A survey of methane point source emissions from coal mines in Shanxi province of China using AHSI on board Gaofen-5B

RC1: ['Comment on egusphere-2023-3047'](#), Anonymous Referee #1, 24 Jan 2024

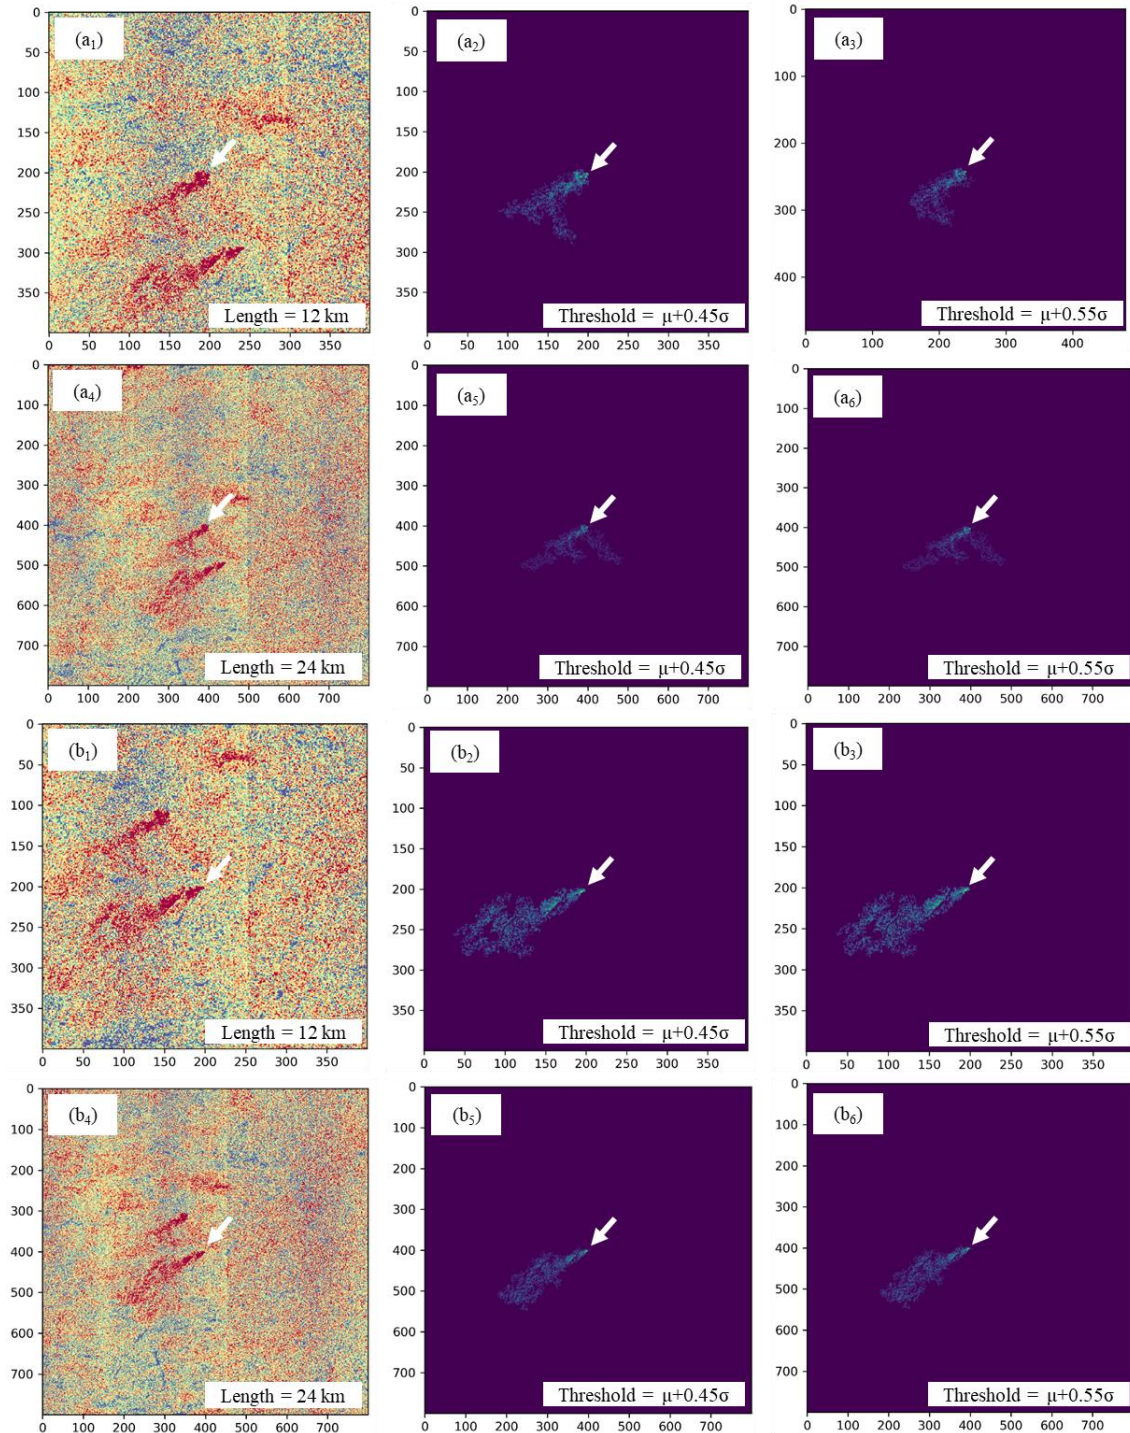
Section 3.3.3: To clarify the IME/measurement uncertainty part of this section, please describe your implementation of the flood-fill algorithm in more detail. It wasn't clear to me, for example, that it depended on defining a background. (And what is that background? See comments below.) Can you please lay this out in a few sentences?

Reply: We added detailed information in Section 3.3.1 (**Lines 200-206**): To carry out the flood-fill method in plume extraction, a background region needs to be defined to calculate the mean and standard deviation of  $\Delta XCH_4$  which set the basis for identifying anomalous high  $\Delta XCH_4$  in the plume relative to the background. In this study, for a specific plume, the origin is first pinpointed through visual interpretation. Then a background region is defined as a square using the source origin as the center for calculating the mean ( $\mu$ ) and standard deviation ( $\sigma$ ) of  $\Delta XCH_4$ . Finally, a threshold defined based on  $\mu$  and  $\sigma$  is used for the flood-fill algorithm to effectively segment the point source plume. The exact numbers for the background square length,  $\mu$  and  $\sigma$  are introduced in Section 3.3.3.

And we revised the description in Section 3.3.3 (Lines 234-237): In practice, for estimating IME and its uncertainty for a certain plume, we used 6 different background square lengths (from 12 km to 24 km with an interval of 2.4 km) and 6 different segmentation thresholds (from  $\mu+0.45\sigma$  to  $\mu+0.55\sigma$  with an interval of  $0.02\sigma$ ) for the flood-fill segmentation method (Figure C1). Different values of  $\mu$  and  $\sigma$  are calculated for different background regions.

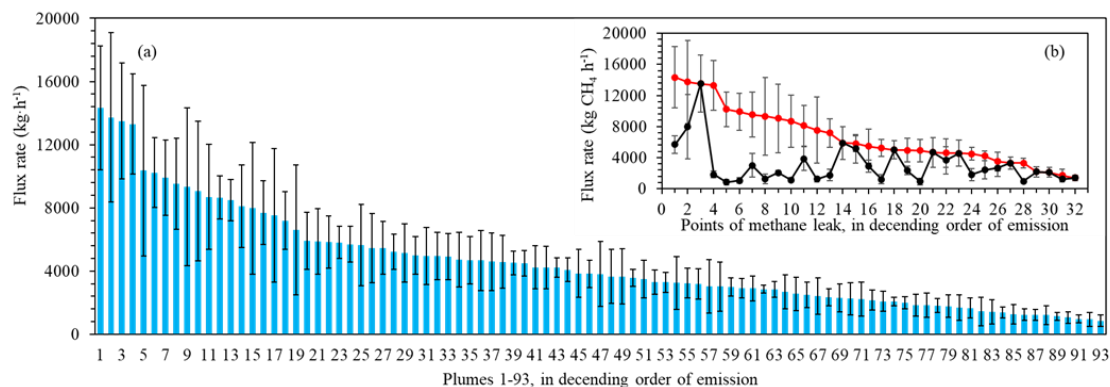
L. 226: A flat 50% wind error would underestimate uncertainty for slow winds and overestimate uncertainty for fast winds. Why not use a fixed absolute wind uncertainty? You have local measurements to compute such an error and that would seem more defensible than an arbitrary 50%.

L. 304: This follows directly from the assumption of 50% wind error, so it's a foregone conclusion. I suggest estimating a typical wind error in m/s for the Shanxi area.

Reply: Thanks for your great suggestion. In the revised paper, we added a paragraph to describe the new results with the wind error estimated from comparing ground-based measurements and ERA5. The comparison result shows an averaged difference of  $1.297 \text{ m}\cdot\text{s}^{-1}$ , which is then used as an absolute wind uncertainty for estimating the uncertainty in emission calculation. The updated results are shown in **Section 4.3.3** and **Figure D1**.

**Lines 410-416:** A flat 50% wind error could underestimate uncertainty for slow winds and overestimate uncertainty for fast winds. Therefore, we carried out an evaluation of the plume emission uncertainty using the absolute wind error ( $1.297 \text{ m}\cdot\text{s}^{-1}$  on average) estimated by comparing wind speeds from ERA5 and local meteorological stations in Shanxi. The results of  $\text{CH}_4$  flux rates and their uncertainty are shown in **Figure E1**. As we expected, the uncertainty of flux decreased/increased at high/low wind speed, respectively. In addition, the impact of wind speed uncertainties accounts for approximately 86.31%, which is similar to the previous result based on a flat 50% wind error. This result supports the fact that wind speed remains the dominant factor contributing to the uncertainty in estimating  $\text{CH}_4$  point source emissions.

Reply: Thanks for your great suggestion and please see our response to your last related comment. In the revised manuscript, we have adopted a fixed absolute wind uncertainty of  $1.297 \text{ m}\cdot\text{s}^{-1}$ , which is the mean difference of wind speeds from EAR5 and local meteorological stations. The detailed descriptions and results are shown in **Section 4.3.3** and **Figure E1 in the Appendix**.

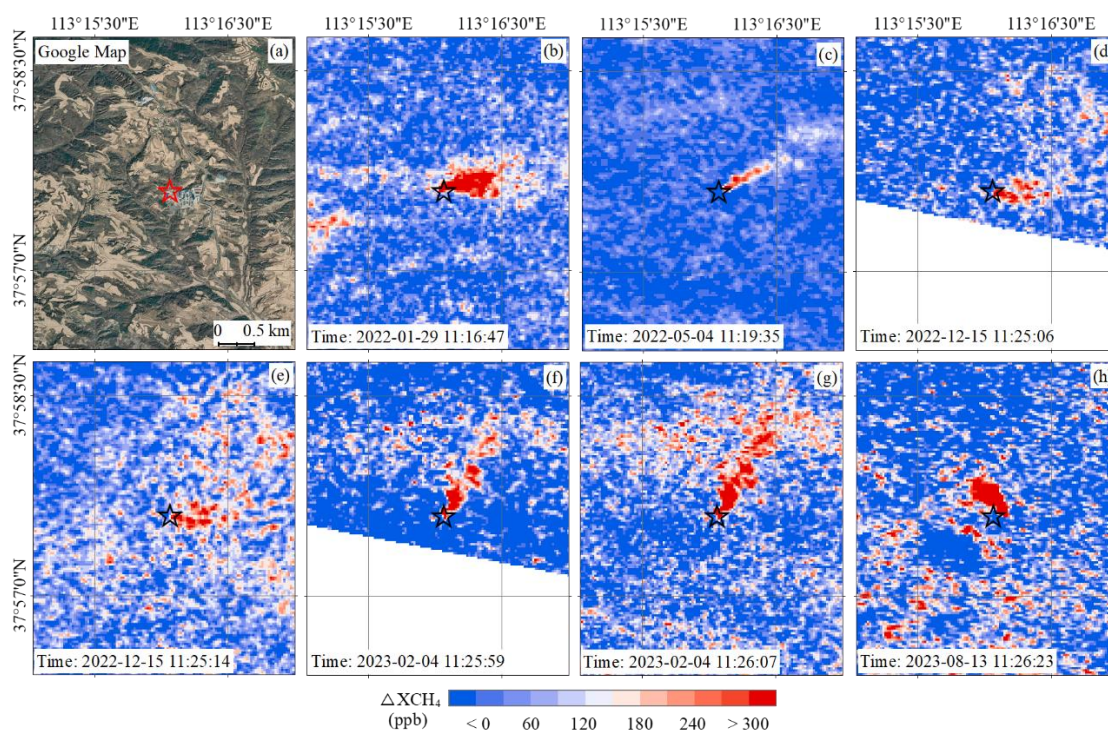
Figure 3: It would be helpful to note the lat/lon of the source somewhere in the caption and main text. What do the black ellipses signify? I assume the inset times are local?

Section 4.1: The discussion of Figure 3 would be easier to follow if the role of the “background” in the retrieval was better explained – see above comment on Sect 3.3.3. At this point it’s unclear to me whether this background is a 2D retrieval image background or a 1D spectral background. Please clarify.

Reply: The location information of the origin (lat 37°57'36", lon 113°16'04") has been added. In order to avoid any ambiguity, we removed the black ellipses and marked the original of the point sources with a red/black star. The observation time is indeed presented in standard Beijing Time (UTC+8; Lon=120°), which is close to the local time (Lon=113°). We have revised the related descriptions in the caption for **Figure 3 (Lines 261-263)**.

Reply: **Figure 3** shows maps of  $\Delta XCH_4$  retrievals derived using **Equation 1**. It requires inputs of  $\mu$  and  $\Sigma$  representing the mean and covariance of the SWIR hyperspectral spectra measurements over background regions, respectively. For the  $\Delta XCH_4$  results in **Figure 3**, the spectral of the full image is used to calculate  $\mu$  and  $\Sigma$  for  $\Delta XCH_4$  retrieval. However, difference in the  $\Delta XCH_4$  results from two nearly simultaneously measured plumes indicate this method is not the optimal. Instead, local background spectra data would be needed in order to improve

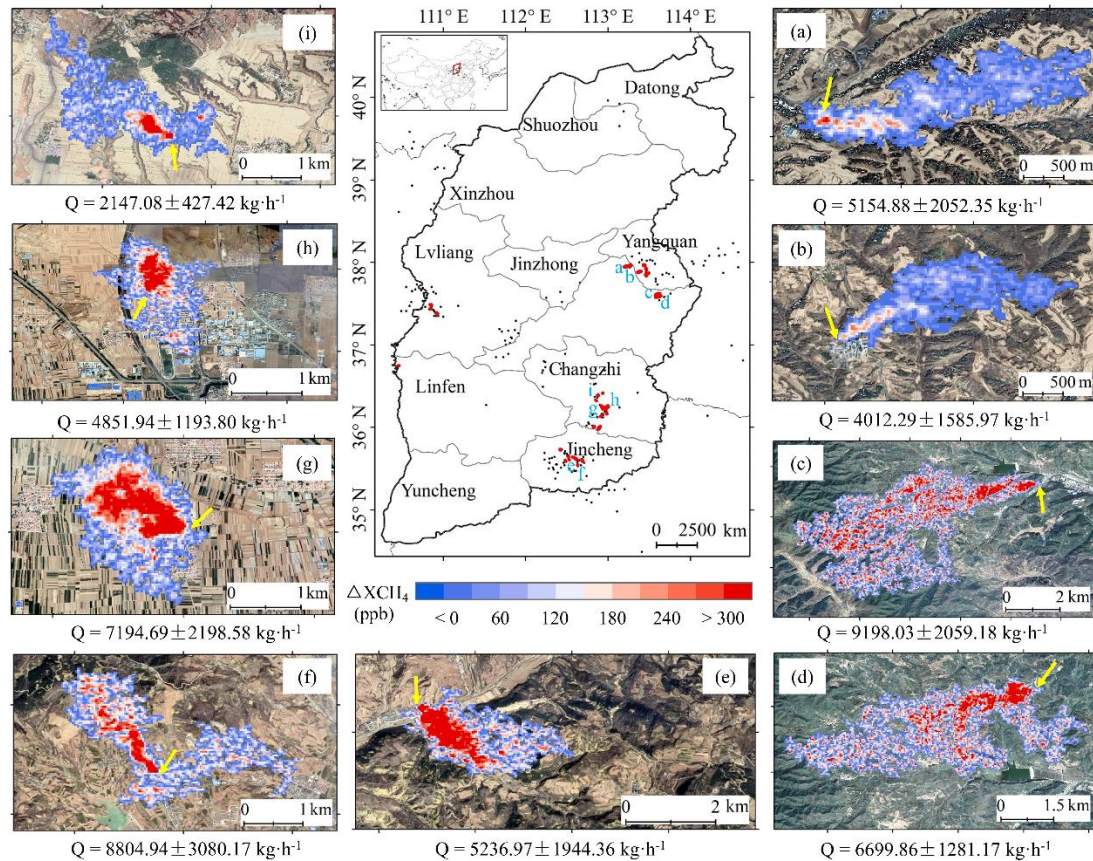
Figure 6: Please mark the source locations on the plot – in some cases I can't tell where the plume starts/ends.

Reply: We have added yellow arrows in Figure 6 to indicate the start of each point source (**Line 342 and Line 346**).
